RE: 8004 Emerald Dr. NW  
Lot 14, Block 11, Unit 24 Unser Cliffs  
Grading and Drainage: Date 1/27/2021(E10D095)  
Revised Grading and Drainage Plan Date: 6/26/2023

Based upon the information provided in your resubmittal received 6/28/2023, this plan is approved for Building Permit.

## DRAINAGE AND TRANSPORTATION INFORMATION SHEET (REV 6/2018)

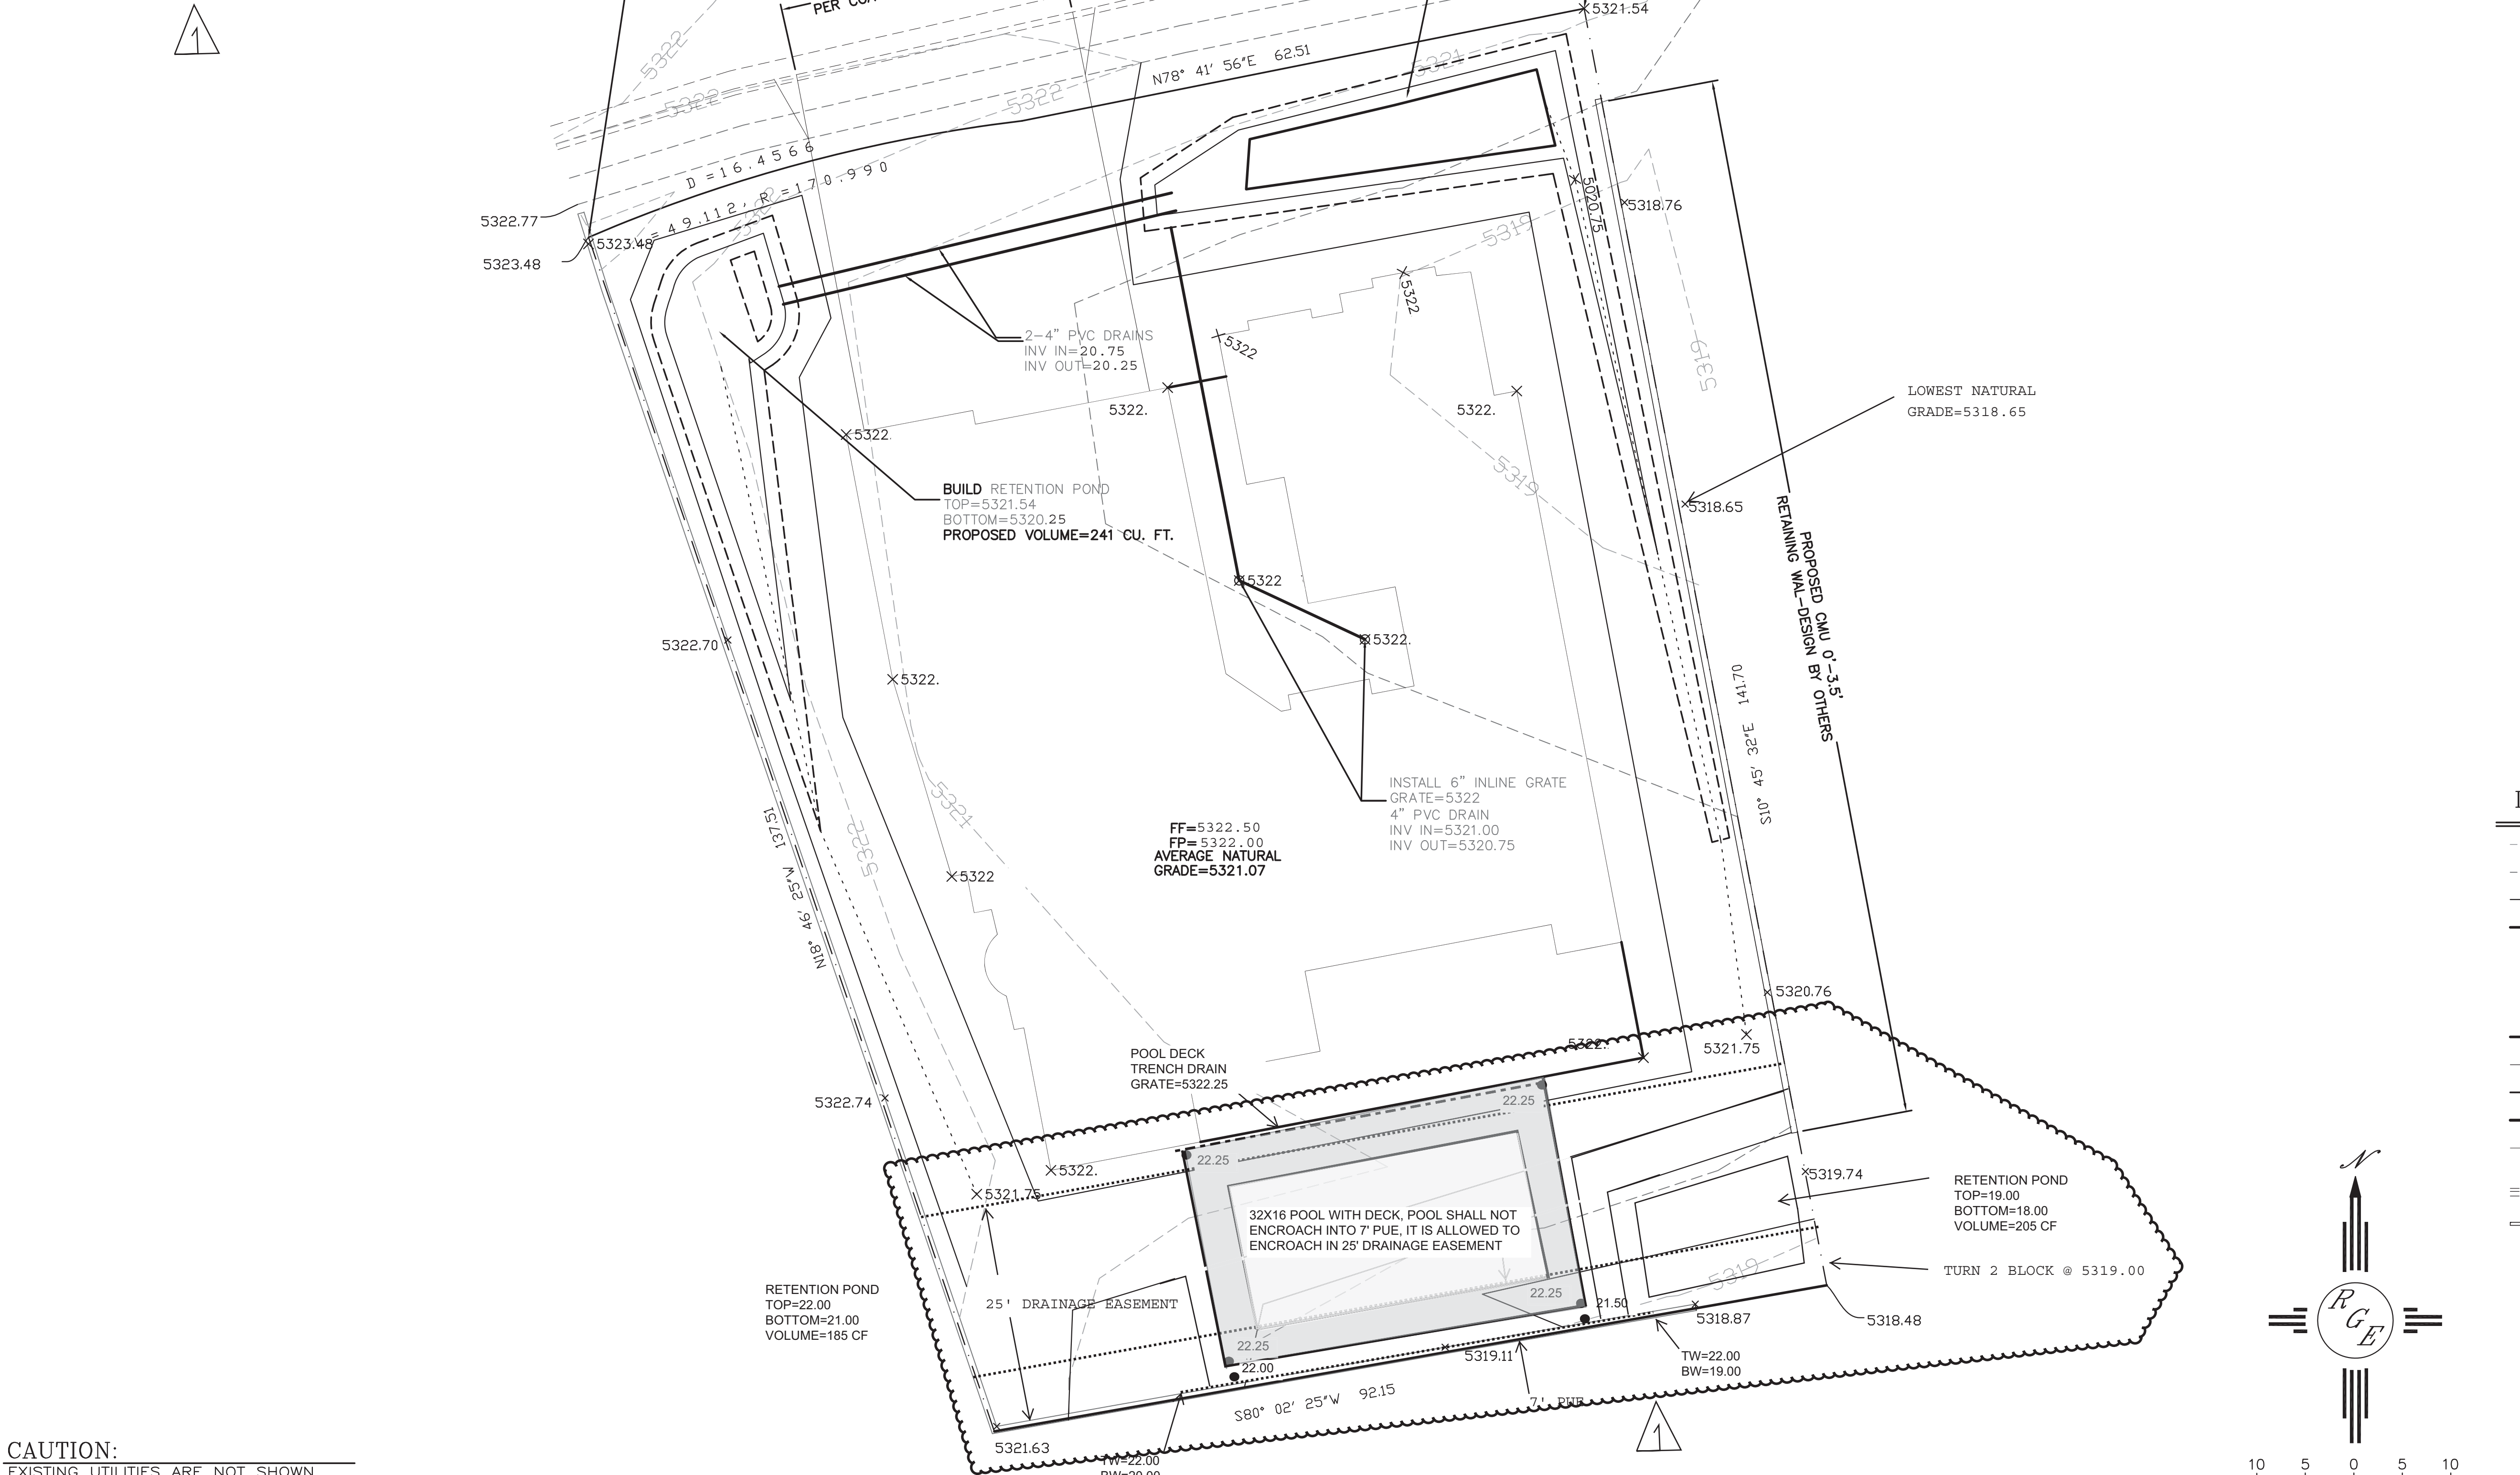
**Reiterate to the Owner/Contractor that a separate permit for a garden/retaining wall must be obtained, with the approved G&D plan. Also, advise the owner/contractor not to use dirt as a ramp to climb the curb. If dirt is used it will cause a delay in permitting.**

Prior to **Certificate of Occupancy release**, Engineer Certification per the DPM checklist of this plan will be required.
